# **PLANNING COMMITTEE Schedule of Supplementary Information**

# Thursday 4th March 2021

05250/19		
Ward	Location	
HONE	MONTCLIFFE QUARRY, GEORGES LANE, HORWICH

09993/20	
Ward	Location
HONE	LAND TO THE EAST OF CENTRAL STREET BOLTON

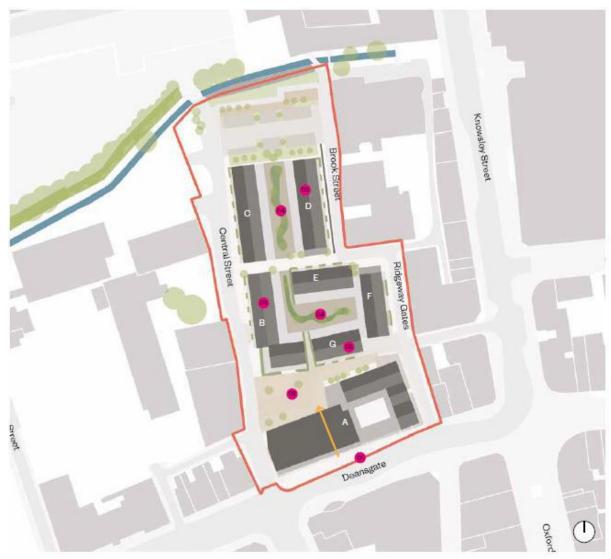
The development proposed is of too high a density and would lead to poor living conditions Project architect Levitt Bernstein has taken the proposal through a comprehensive and considered design evolution process. There is no sound basis for comparing average dwelling size within the proposed development to the national average for new homes. There are nine types of homes proposed, with the largest being a two-bedroom town house. The national average size of new homes in England includes homes of all sizes across urban, suburban and rural locations. This cannot be reasonably compared with the average dwelling size in a high-density urban regeneration project. A key objective of national planning guidance is to seek uplift in the average density of residential development within city and town centres (paragraph 123 - the framework- National Planning Policy Framework) and the proposed development responds to this. The submitted Design and Access Statement sets out details of compliance with the Nationally Described Space Standards (NDSS) for residential development.

Levitt Bernstein undertook an exercise considering residential amenity, to test the quality of light throughout the scheme. This demonstrated good living standards and was undertaken when a much higher density (230 apartment) scheme was under consideration at preapplication stage. The proposal is now at a much lower density and benefits from larger courtyards areas, resulting in a substantial amenity improvement on what was previously planned. It is important to appreciate that a significant proportion of the dwellings are dual aspect to maximise daylight levels and internal sunlight penetration, as well as aiding ventilation. Although a sunpath analysis was not required as part of the planning application's validation requirements, robust assessments by the design team were undertaken in the interests of achieving the best possible composition of development. Both shared residential courtyards and both Block A roof terraces meet applicable BRE guidance standards.
